**Subject:** Letter of Clarification No. 1 to Invitation to Bid No. S50-C23530 to Furnish and Install a New 800 KW Generator at Houston TranStar for the Public Works and Engineering Department

FURNISH AND INSTALL A NEW 800 KW GENERATOR AT  
HOUSTON TRANSTAR

**ADDENDUM #1 (January 27, 2010)**

**Revised 01/25/2010**

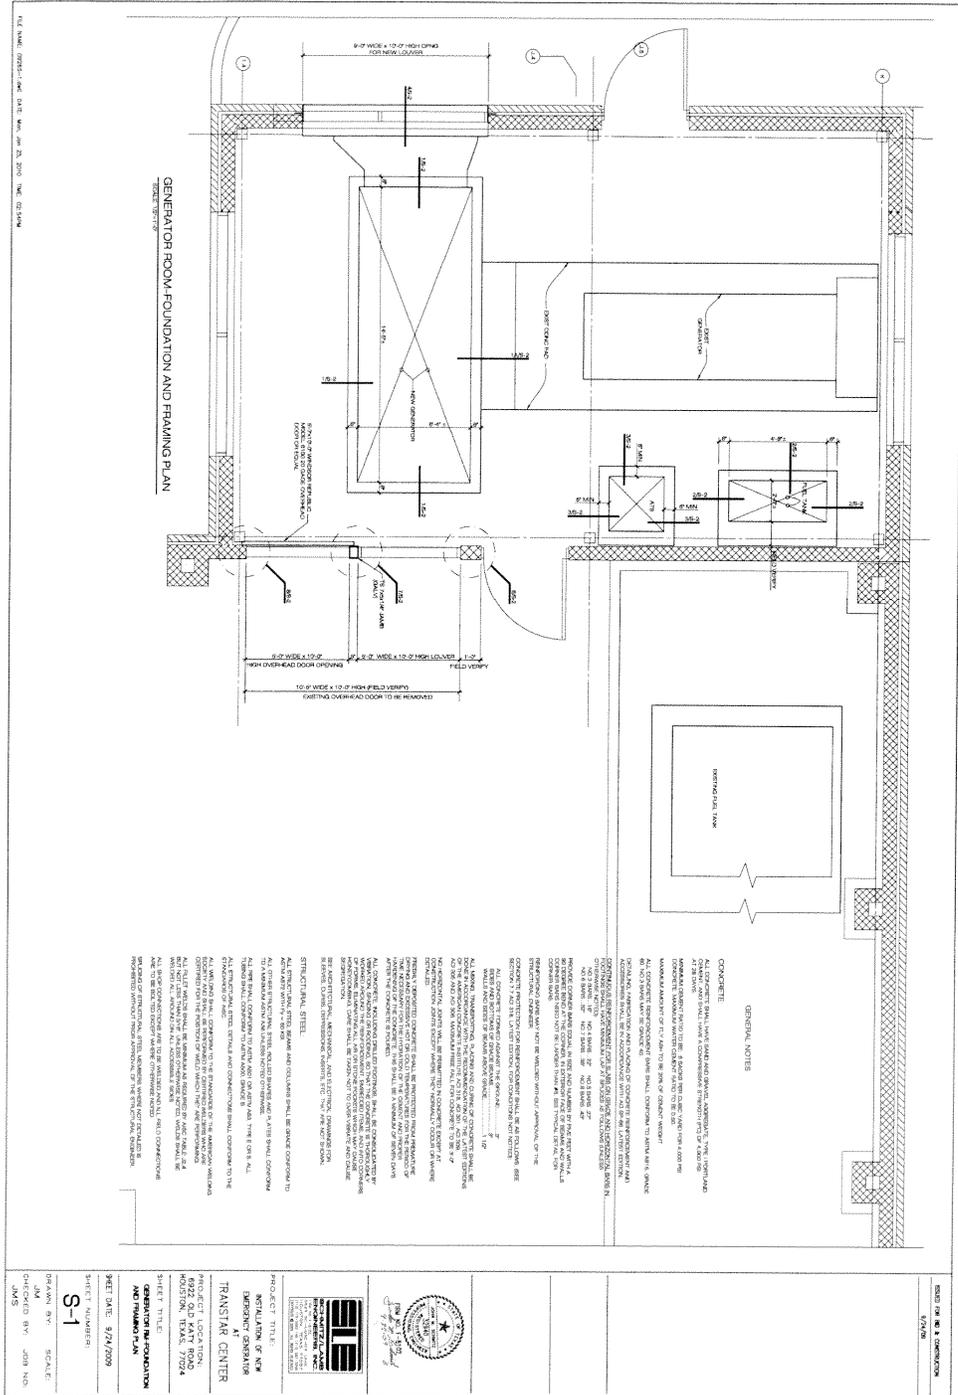
***1.1.1.9 As an Option: the Contractor shall provide a second new 800 KW 277/480 volt, 3 phase, 4 wire, diesel fuel, new emergency generator on skids. This second generator will be a duplicate of the first, but will not be installed; it will be left at owner's site.***
